Design Review Commission Report

Meeting Date: Thursday, December 5, 2013

Subject: 713 Arden Drive (PL1331141)

A request for an R-1 Design Review Permit to allow a revision to a previously approved façade remodel to an existing two-story single-family residence located in the Central Area of the City north of Santa Monica Boulevard. The Commission will also consider adoption of a Categorical Exemption, pursuant to the California Environmental Quality Act.

C-STREETScape WITH PROPOSED LANDSCAPE

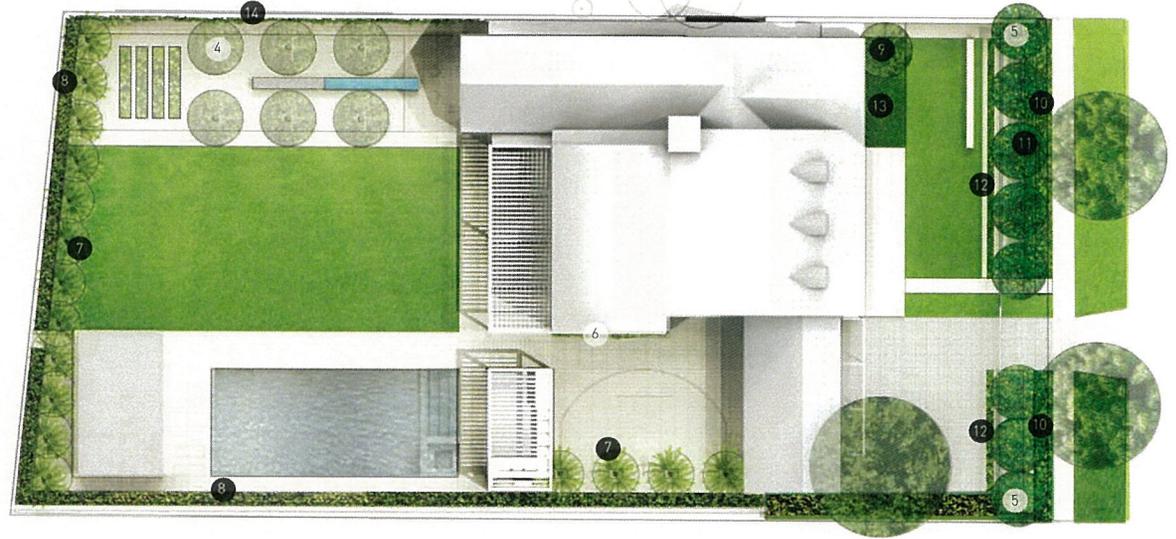
Based on a review conducted by the City's Urban Designer, the new roof configuration over the front facing garage creates an unarticulated linear massing that lacks appropriate detailing. Additionally, the items that previously mitigated the massing in this area, such as the dormer and breezeway, are proposed to be removed. While the front facing garage is softened by the trellis, the garage doors present a challenge to the streetscape and its compatibility. Furthermore, the new front yard fence does not appear to enhance the streetscape.
